**CITY OF ESSEX JUNCTION  
DEVELOPMENT REVIEW BOARD  
PUBLIC HEARING AGENDA**

## Staff Report

**To:** Development Review Board  
**From:** Michael Giguere, City Planner  
**Meeting Date:** June 9<sup>th</sup>, 2025  
**Subject:** Site plan review for the conversion of an existing duplex into a fourplex at 177 West Street by Adam and Eva Slocum, owners - waiver request for the paved driveway apron requirement of Section 703.K.3 of the Land Development Code.

Figure 1: Site plan showing the portion of the driveway and apron that is required to be paved per Section 703.K.3.

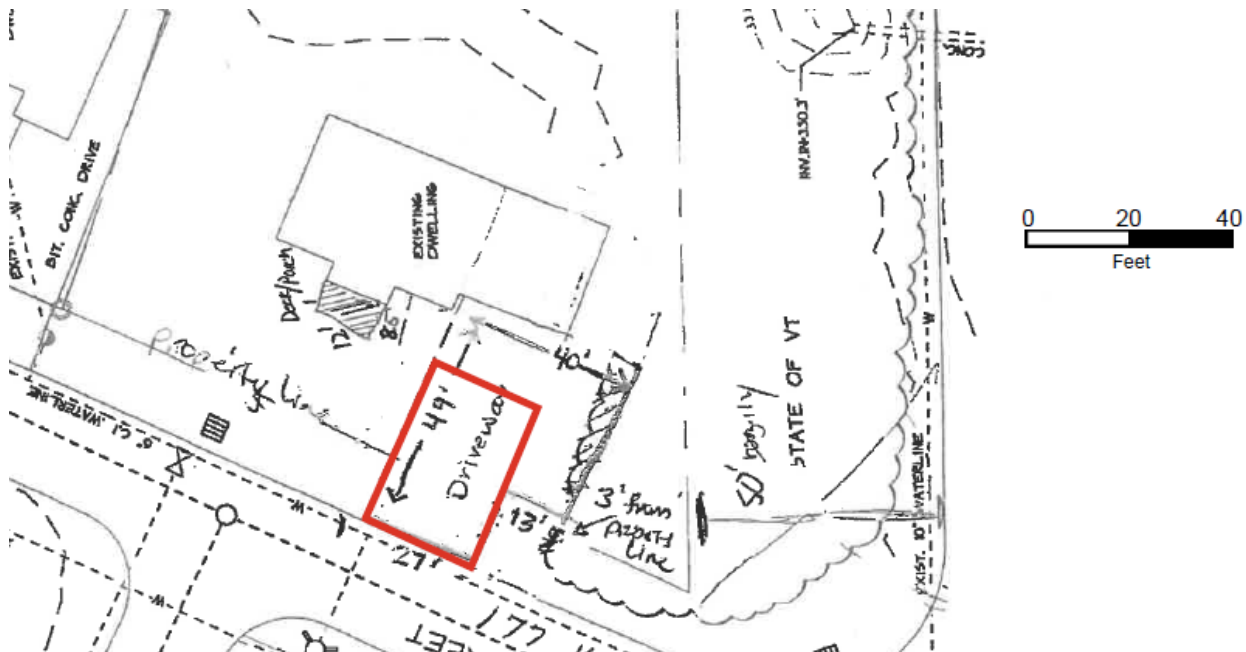
The applicant proposes maintaining the existing gravel driveway surface and requests that the hard-surfaced requirement be waived.

When Section 703.K.3 was originally added to the LDC, it used Section 713 (Stormwater Management) as its waiver evaluation criteria, allowing the Planning Commission to waive the requirement that driveway aprons be paved if it was determined that *"no significant drainage problems will result from the development"* with technical guidance from the Village Engineer.

Section 713 was updated in 2007 to modernize the Village's stormwater management practices. However, when this change was made, evaluation criteria for the paved driveway requirements were removed. Thus, the LDC allows applicants to request this waiver but does not provide further guidance on how it should be evaluated.

Notably, paved driveways are preferable for street maintenance as it prevents loose gravel from being tracked onto the road. Most other driveways on the street are paved and it is clear that new construction should generally be held to current standards. However, this project proposes the retrofit of an existing building which may suggest some leniency may be reasonable.

**The DRB should consider whether to grant a waiver of the paved driveway requirement of Section 703.K.3.**
